UNITED STATES PATENT AND TRADEMARK OFFICE

| APPLICATION NO. | FILING DATE | FIRST NAMED INVENTOR | ATTORNEY DOCKET NO. | CONFIRMATION NO. |
|-----------------|-------------|----------------------|---------------------|------------------|
| 10/661,116 | 09/12/2003 | Martin A. Putnam | CV-0044 | 6433 |

DETAILED ACTION

FIG. 27

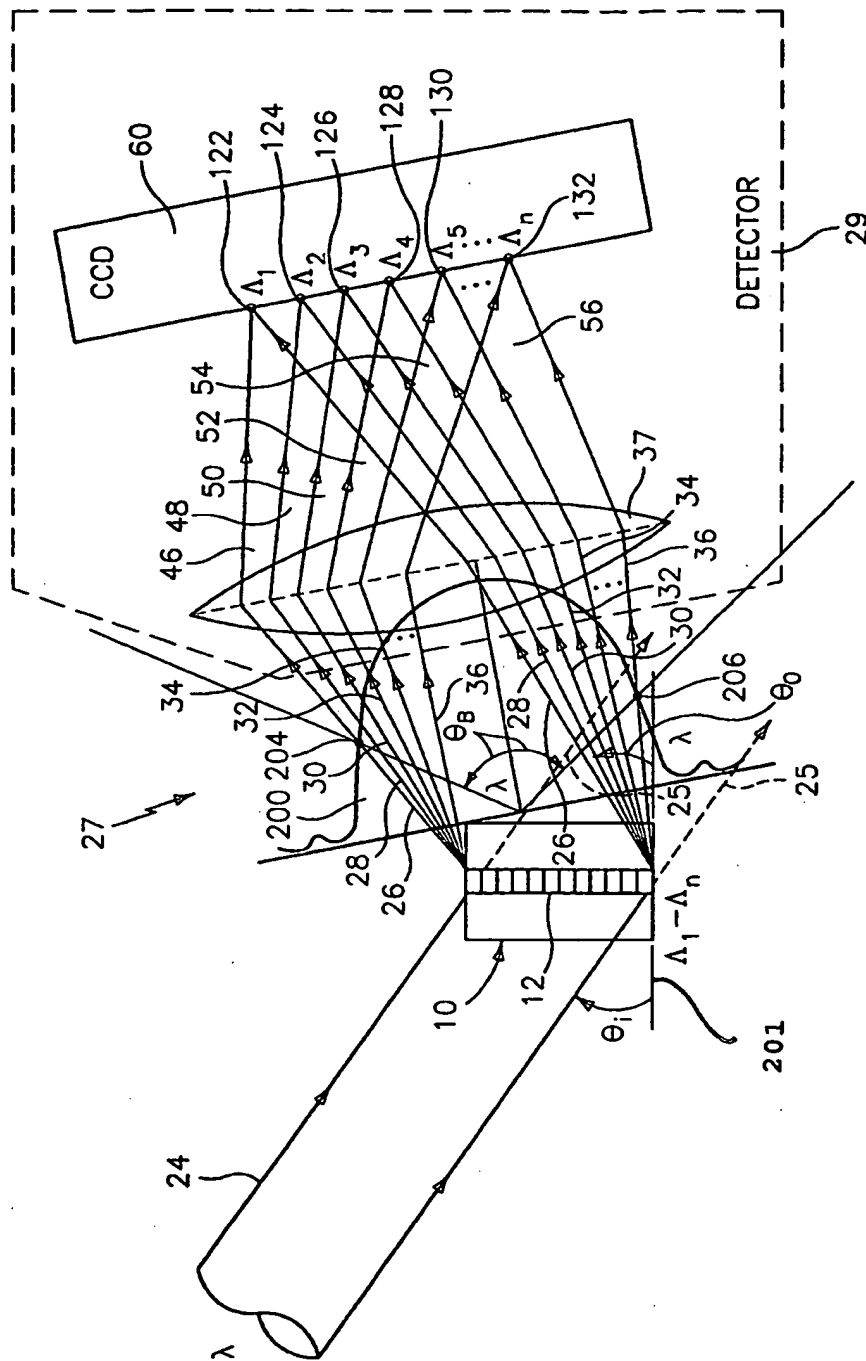
2. The drawings were received on 2/16/05. These drawings are objected to for the following reason(s) as set forth below.
3. The drawings are objected to as failing to comply with 37 CFR 1.84(p)(5) because they do not include the following reference sign(s) mentioned in the description:

Figure 27- Reference numeral 203 (See Page 19, lines 12 and 14).

Corrected drawing sheets in compliance with 37 CFR 1.121(d) are required in reply to the Office action to avoid abandonment of the application. Any amended replacement drawing sheet should include all of the figures appearing on the immediate prior version of the sheet, even if only one figure is being amended. Each drawing sheet submitted after the filing date of an application must be labeled in the top margin as either "Replacement Sheet" or "New Sheet" pursuant to 37 CFR 1.121(d). If the changes are not accepted by the examiner, the applicant will be notified and informed of any required corrective action in the next Office action. The objection to the drawings will not be held in abeyance.
